Preliminary Analysis of the Wolverine World Wide Draft Tannery Interceptor System Response Activity Plan

Richard R. Rediske, Ph.D.

Groundwater Contamination at the Tannery and Proposed Extraction Well System

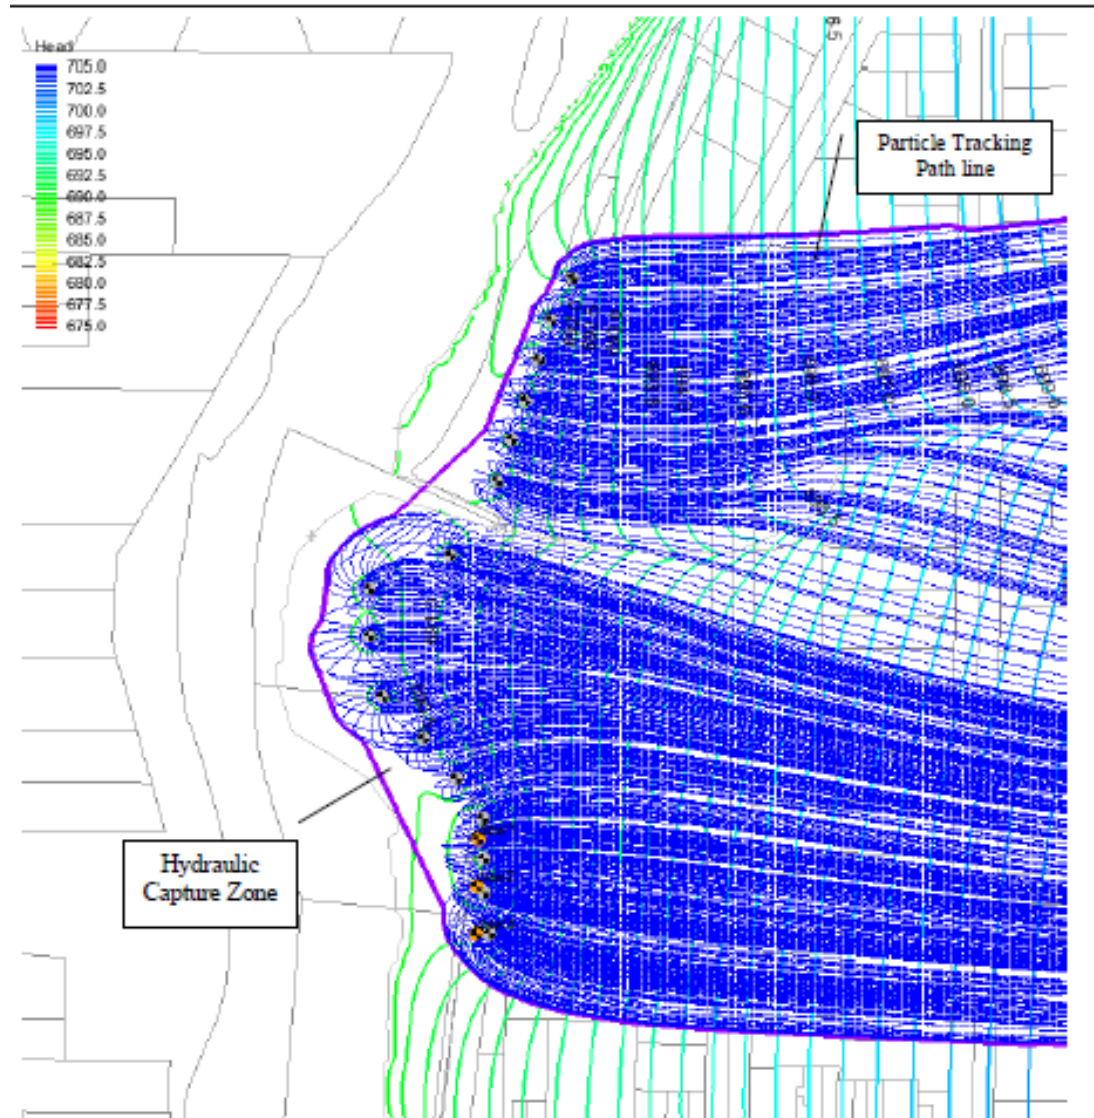
Following installation of the system, R&W/GZA will implement a program to monitor the effectiveness of the system at capturing the groundwater plume. Twelve piezometers will be installed and two existing groundwater monitoring wells will also be utilized (Sheet No. 7). These 14 piezometers/monitoring wells are located mid-way between the extraction wells, where the drawdowns are expected to be the smallest. Two staff gauges, north and south of Rum Creek, will be installed in the Rogue River. Water level measurements from the two staff gauges in the Rogue River and 14 piezometers/monitoring wells will be measured weekly and compared to evaluate the system performance. An inward hydraulic gradient, which would indicate successful groundwater capture, is considered to be achieved when the groundwater elevations in the piezometers/monitoring wells are lower than that of the nearby staff gauge. Additionally, transducers will be installed in each extraction well for operation and maintenance purposes. Groundwater elevation and flow rate data from the individual extraction wells will also be reviewed to evaluate well performance. If performance monitoring indicates that the system or any individual well is either drawing too much water from the river or conversely not capturing groundwater as it reaches the well network, diagnosis will be performed and system maintenance work or modifications will be carried out as appropriate. **The monitoring program will not include groundwater sampling.**
